MANISTEE CITY PLANNING COMMISSION

Special Meeting of Tuesday, November 28, 2006
7:30 p.m. -Council Chambers, City Hall, 70 Maple Street,
Manistee, Michigan

Staff/Site Plan Review for:	Manistee G.B. LLC, Inc 105 W. Exchange Street, Spring Lake, MI 49456
Address/Parcel Code#:	282 Twelfth Street/51-51-661-001-00
Zoning District:	C-1 Regional Commercial District
Proposed Use:	Goodwill Retail Store (Use Permitted by Right)

Staff/Site Plan Review for: City of Manistee Fifth Avenue Beach House

Redstone Commercial Investment
New Manistee Goodwill Store
10/25/06

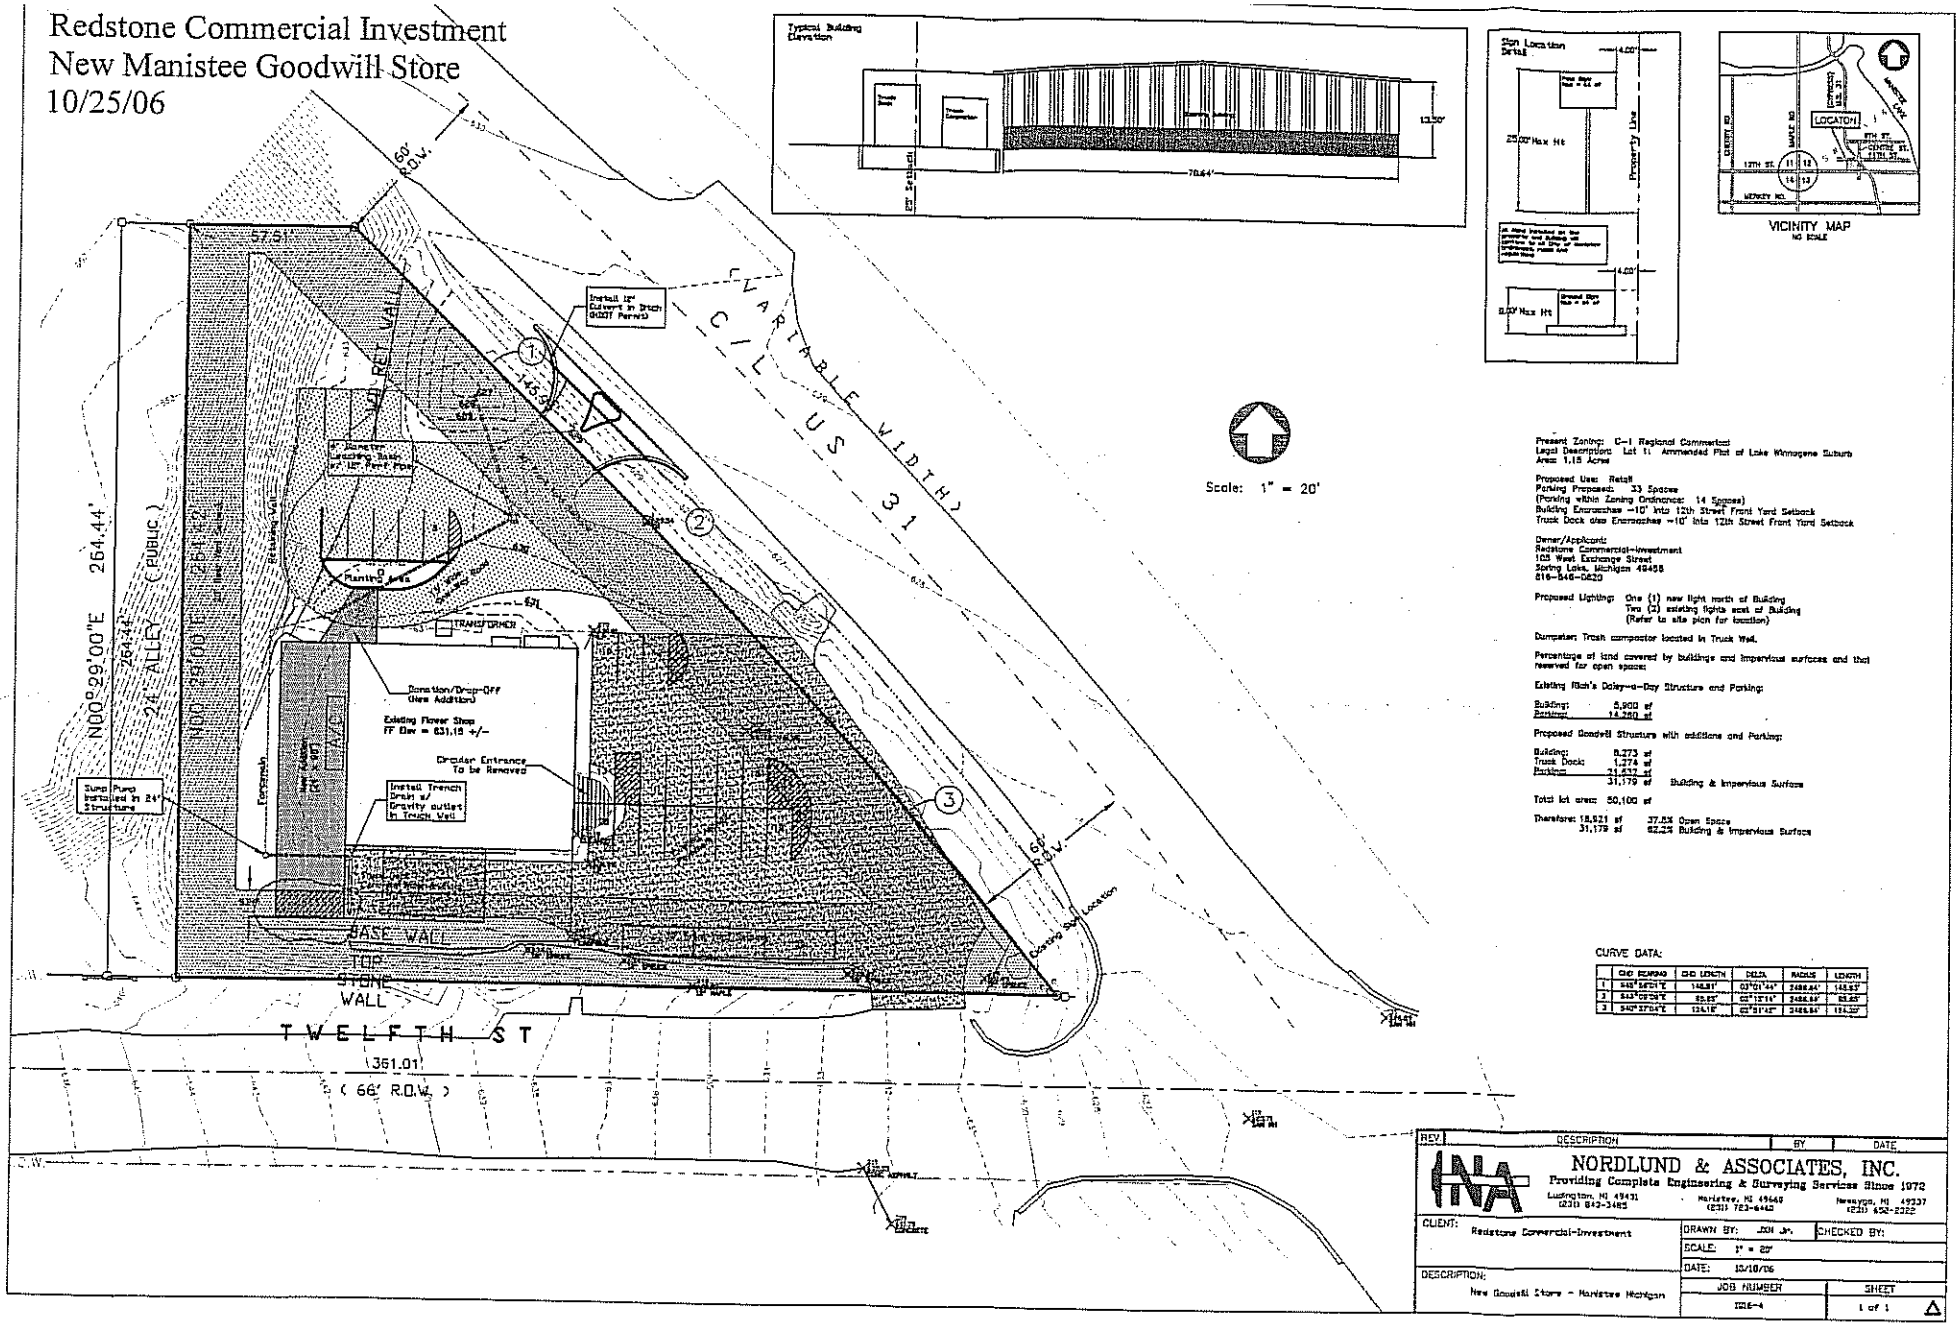
NOTES: Four (4) parking spaces (#12, #27, #28, #29) encroach into the front yard set back but are pre-existing legal non-conformity. Using the definition from the Zoning Ordinance the amount of lot that is covered with buildings is 16.5%.

MDOT has reviewed and approved a "right in" "right out" curb cut onto U.S. 31. Specific design and signage for the entrance/exit will be approved by MDOT.

1. We have added a detail to the site plan showing a typical location for a pole mounted and ground sign. Also, any signs affixed to the building, or installed on the property will be in accordance with the sign regulations found in the zoning ordinance.

2. Lighting on the parking lot will be provided by two existing light poles, and one proposed light located north of the building. A wall pack light will likely be utilized in the truck dock. Other wall pack lights may be necessary for security and lighting purposes.

3. Along the north side of the building, a parking lot, circle drive and donation center must be constructed. The grades for the top of the asphalt surface are provided. A small retaining wall, or slope treatment may be necessary against the steep embankment to the west.

4. We have added a detail showing elevation view of the proposed building – which is not really going to change significantly.

5TH AVENUE BEACH HOUSE PLAN SHEET

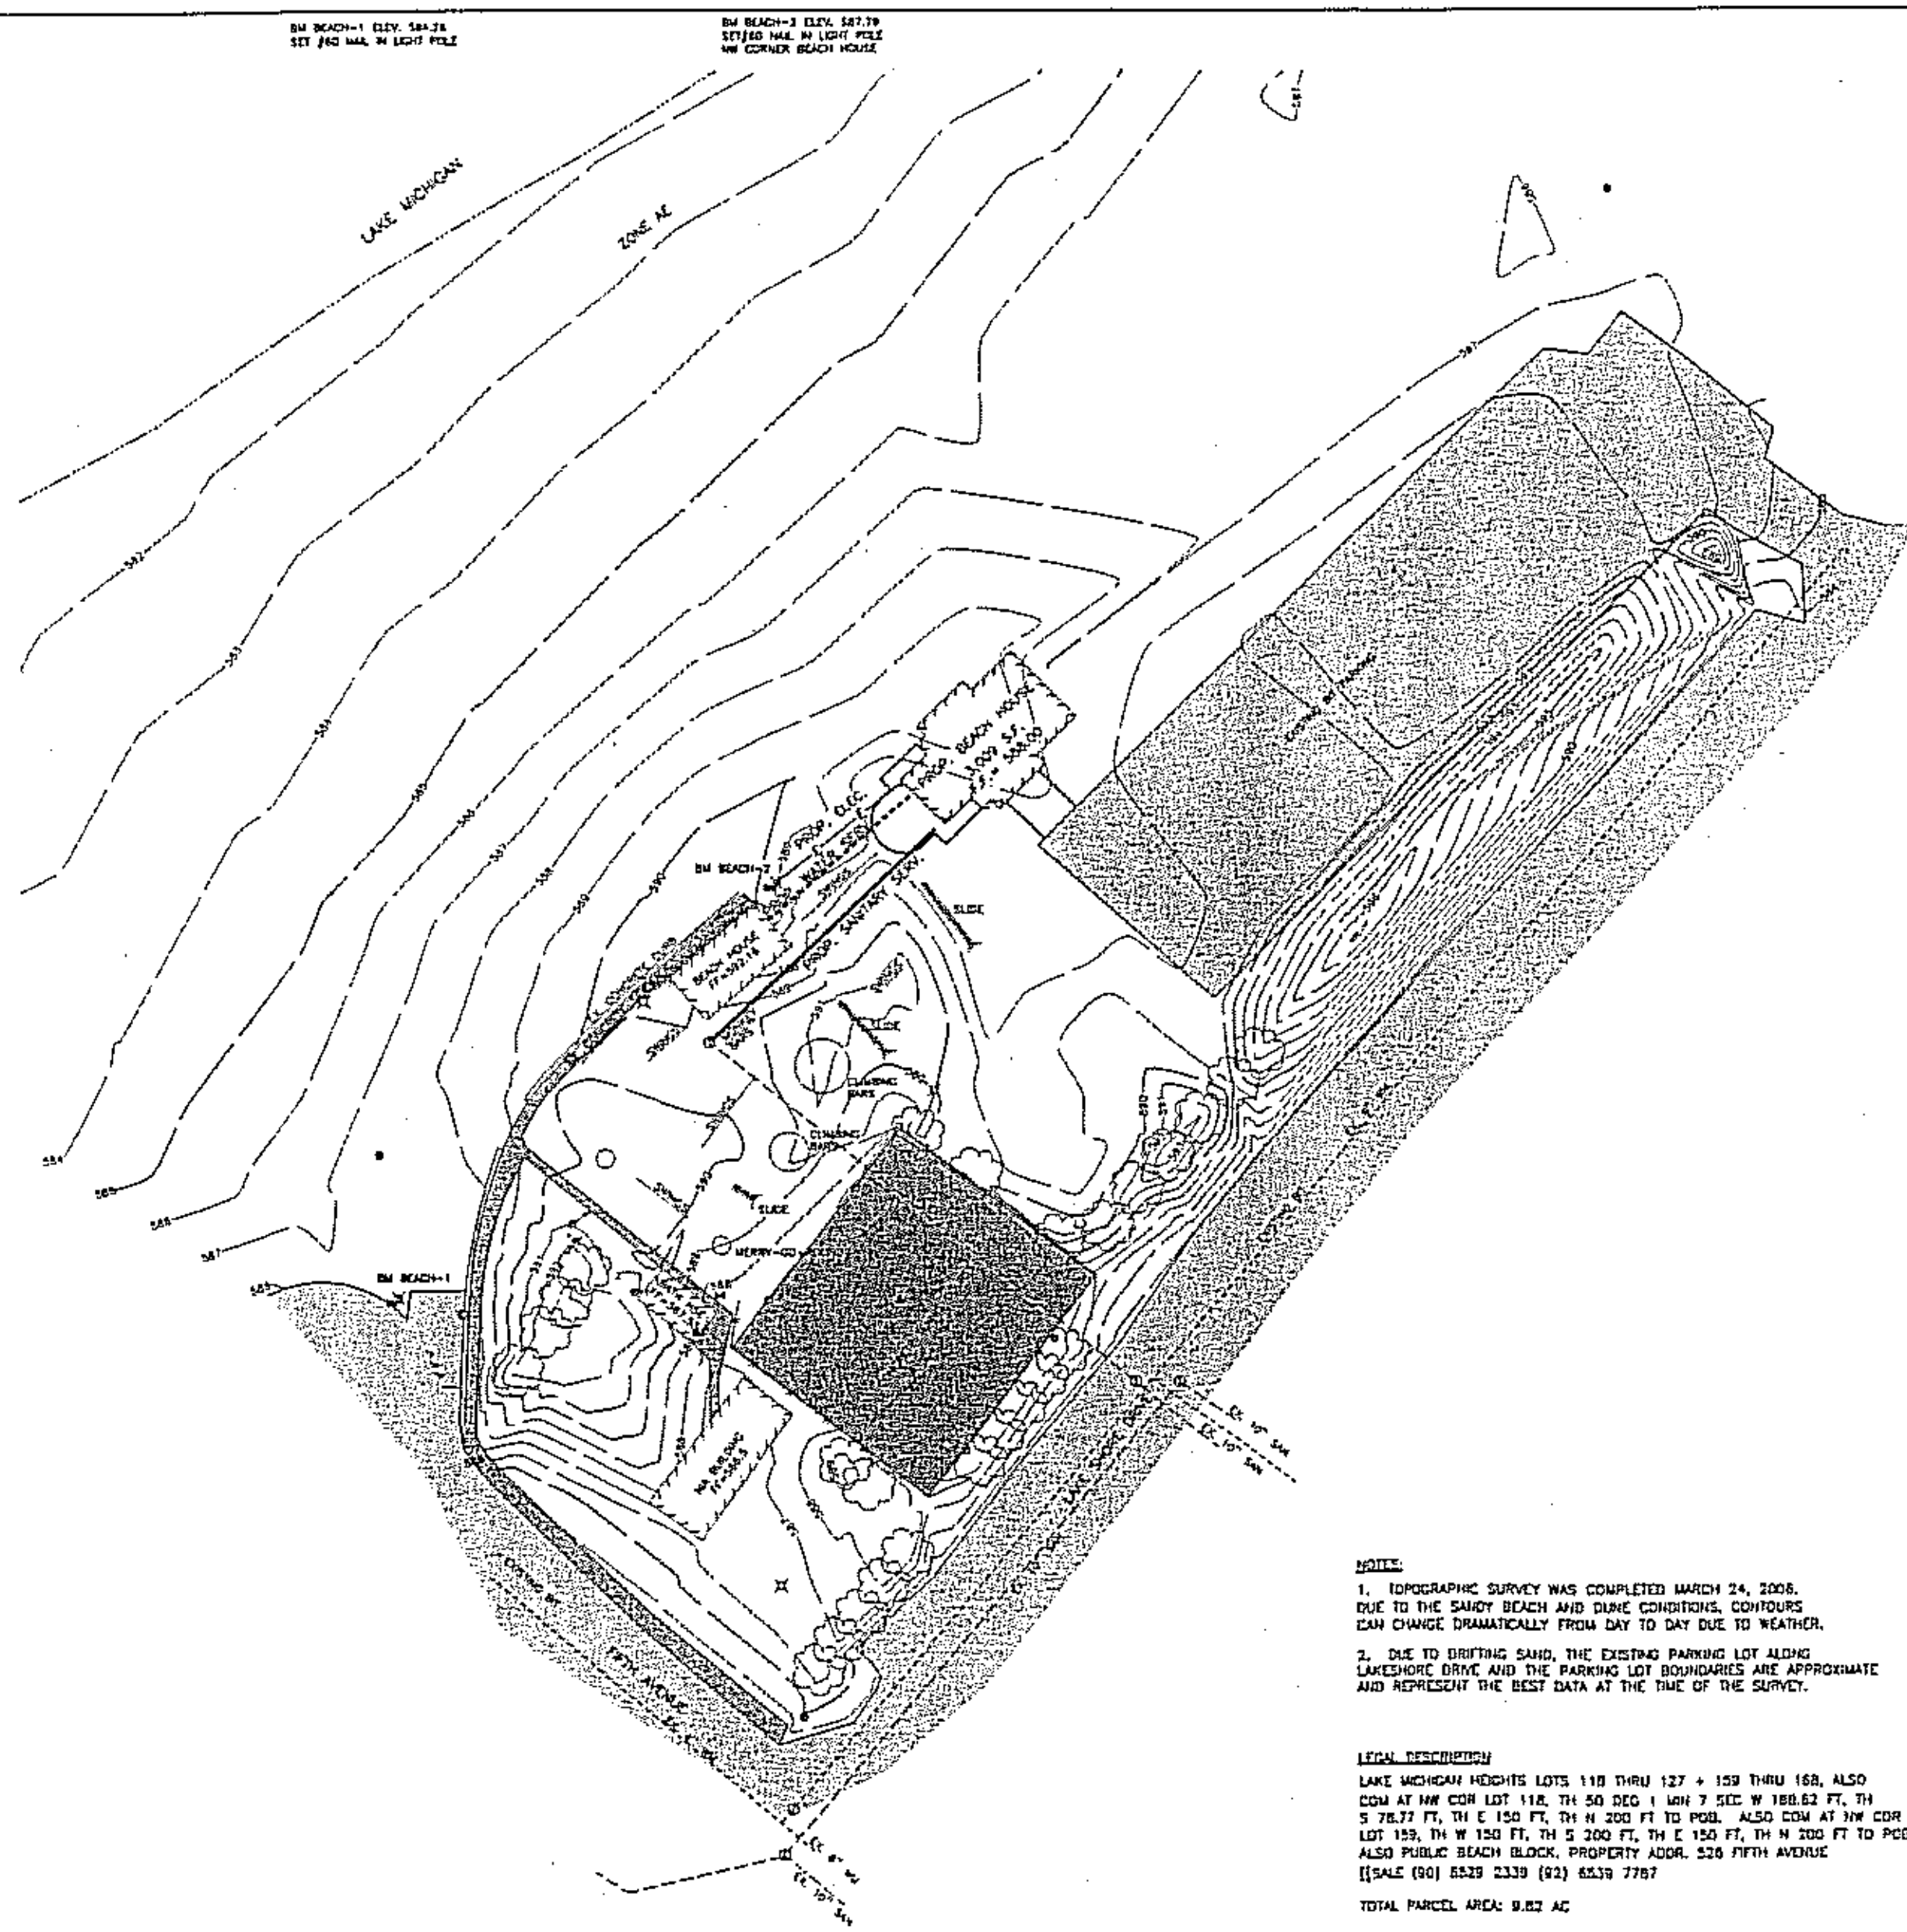
NOTES: Review of the request shows that the requirements of the Zoning Ordinance have been met
